Reviewed for **General Acceptance only.** This review does not relieve Subcontractor of its responsibility to conform to Contract Documents. The Subcontractor is responsible for all dimensions, correct fabrication and accurate fit with the work of trades.

REVIEWED AND NOTED FOR DESIGN INTENT ONLY. DIMENSIONS & QUANTITIES NOT GUARANTEED ☒

JOB NAME: WOODWAY HIGH SCHOOL
LOCATION: 23200 100TH. AVE. WEST
EDMONDS, WA. 98020
(BUILDING B-1)
CONTRACTOR: SGA
DESCRIPTION: COLUMN DETAILS

- ☐ NO EXCEPTIONS TAKEN
- ☒ MAKE CORRECTIONS NOTED
- ☐ REVISE & RESUBMIT
- ☐ REJECTED

Dwn. by: SEB | Chkd. by:
Scale N.T.S.
Date 6-28-02
Job No. | Sheet
02 F 17 | D1

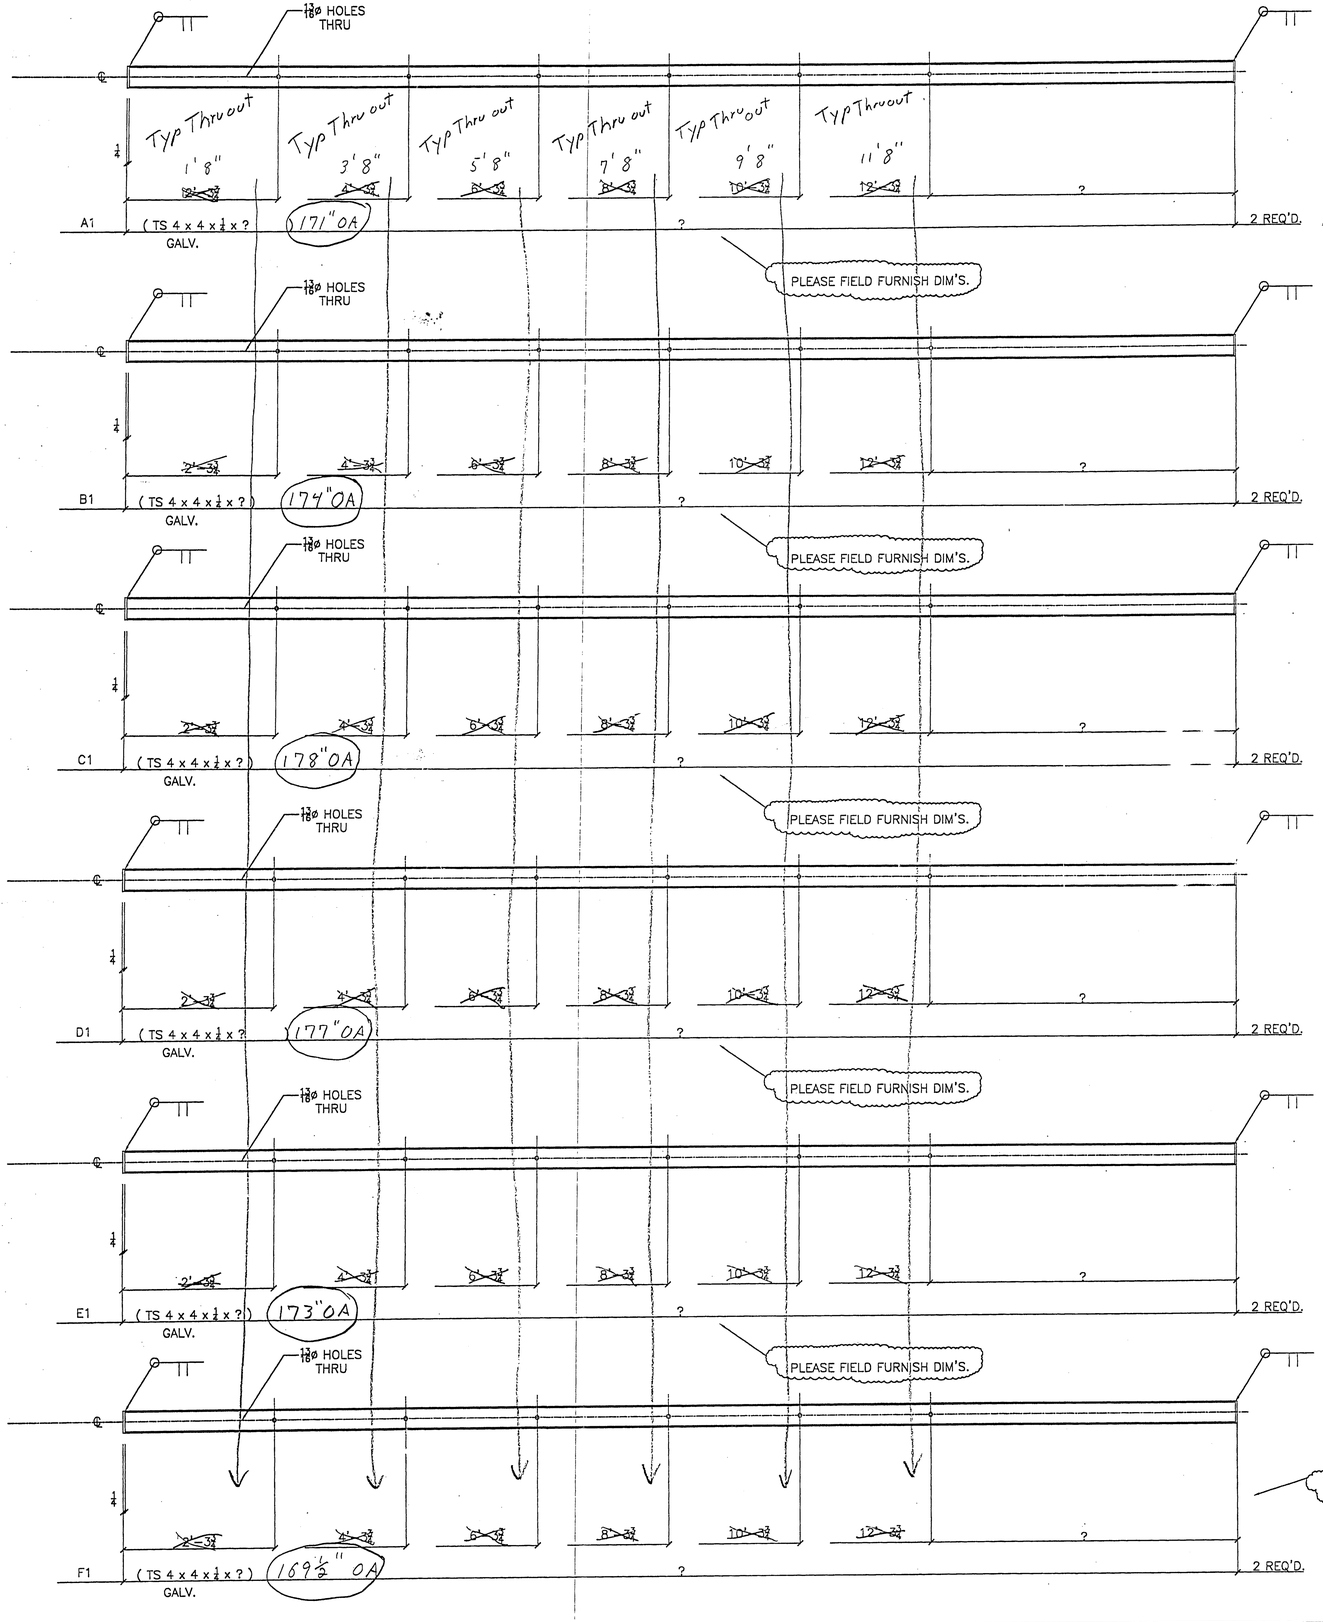
* weep holes required in the top and bottom plates

* weep holes may be required in tube at each end

Dwn. by: SEB	Chkd. by:
Scale N.T.S.	
Date 6-28-02	
Job No.	Sheet
02 F 17	D2

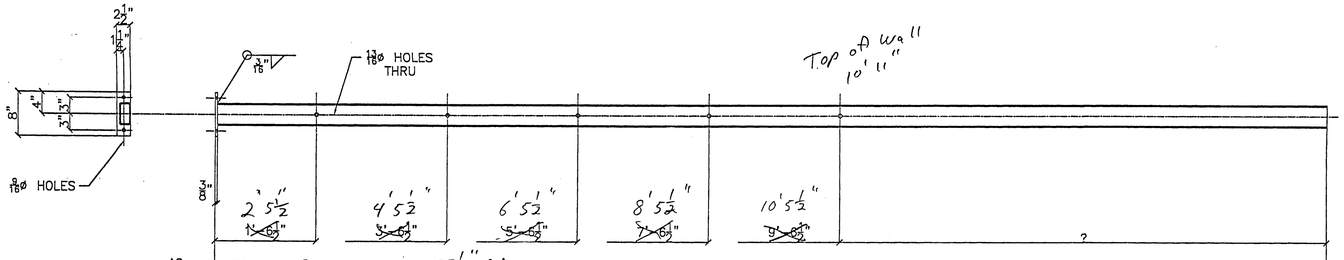
PLEASE FURNISH FIELD DIM'S.

Interior steel to be shop primed, typ.

JOB NAME: WOODWAY HIGH SCHOOL LOCATION: 23200 100TH. AVE. WEST EDMONDS, WA. 98020 (BUILDING B-1)	Dwn. by: SEB Chkd. by: Scale N.T.S. Date 7-1-02
CONTRACTOR: SGA	Job No. 02 F 17 / Sheet D3
DESCRIPTION: LEDGER ANGLES, MISC. CONN. PLATES & ANGLES

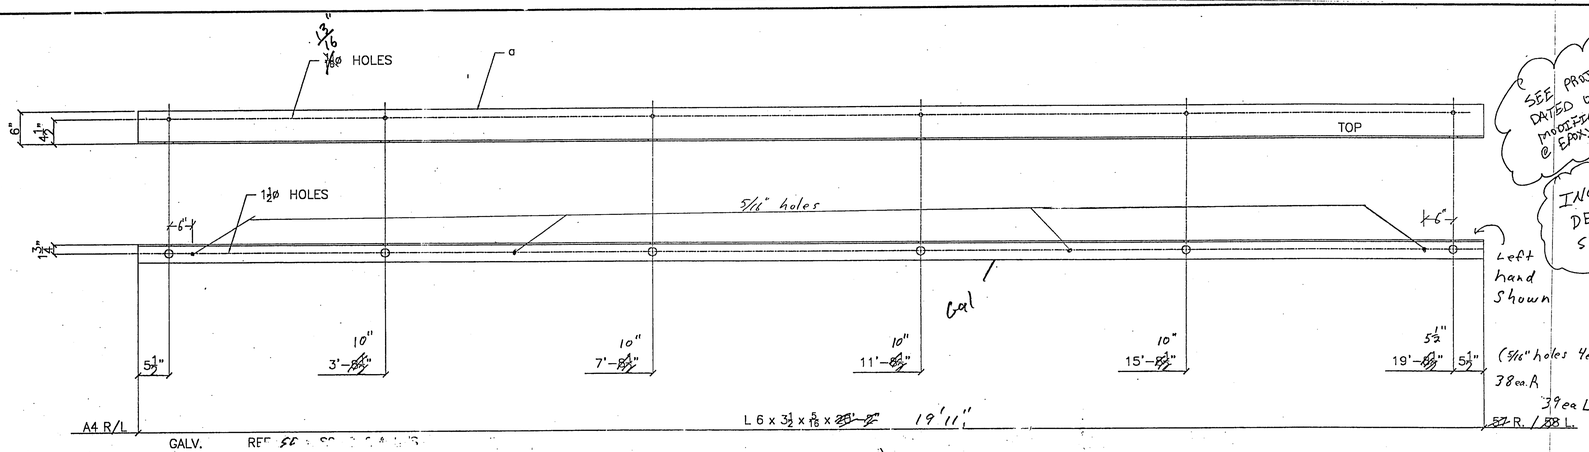
SEE PROJECT RECORD DATED 07/12/02 FOR MODIFICATION TO HOLE SIZE @ EPOXY BOLTS

INCLUDE 4's PER DETAIL 15/S4.2 SEE BLDG. B-1

PLEASE FIELD VERIFY DIM.

10 ea
A5 – CONN. PLATES – ~~4~~ REQ'D.

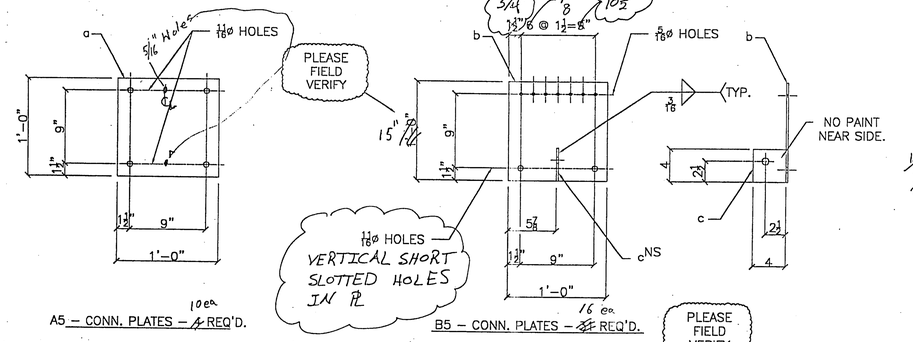
ARE THERE RIGHT HAND ~~& LEFT HAND~~

all Right hand

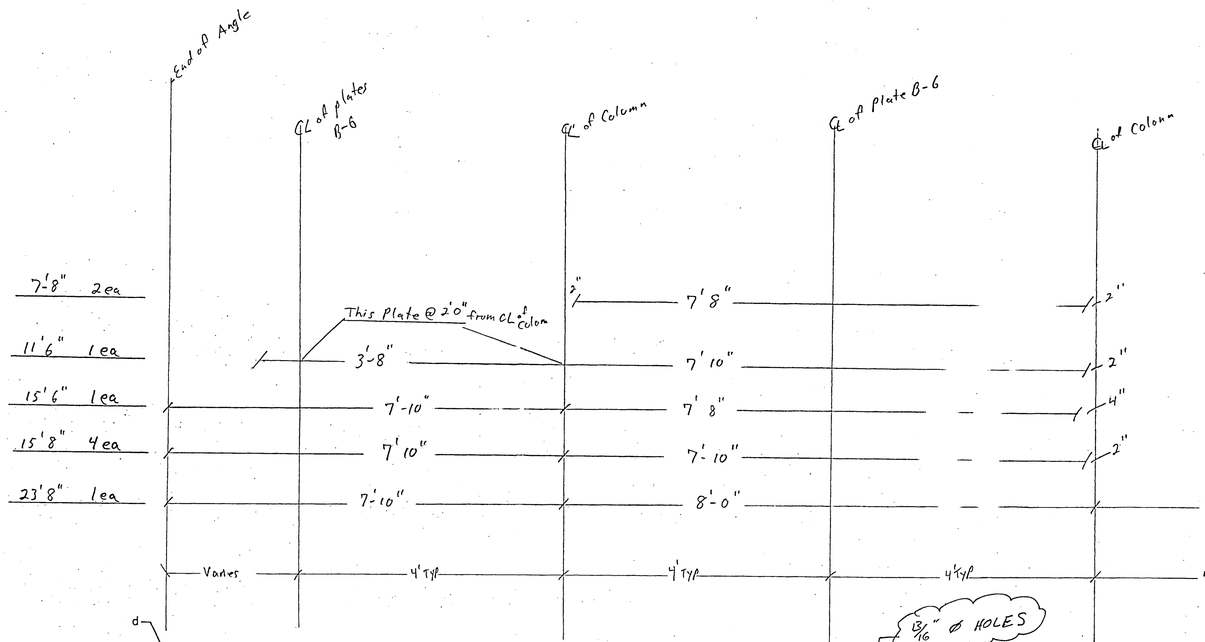
ARE THERE RIGHT HAND ~~& LEFT HAND~~

all Right hand

REF.: S2.13 & 17/S4.1

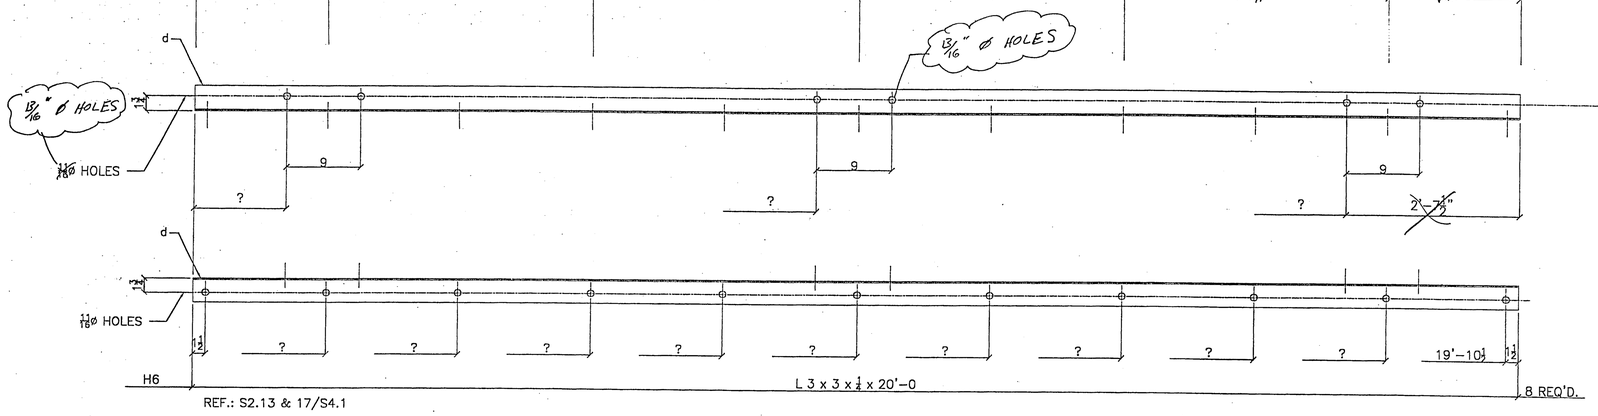
PLEASE FURNISH HOLE SPACIG

REF.: S2.14 & 12/S4.1 Right Hand

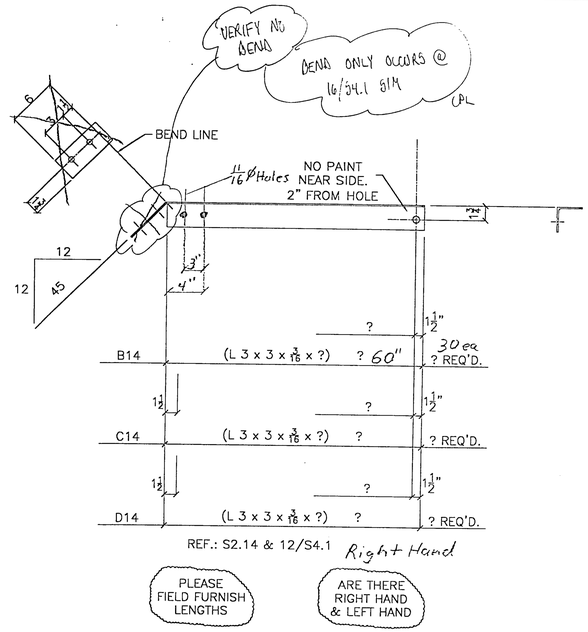
PLEASE FIELD FURNISH LENGTHS
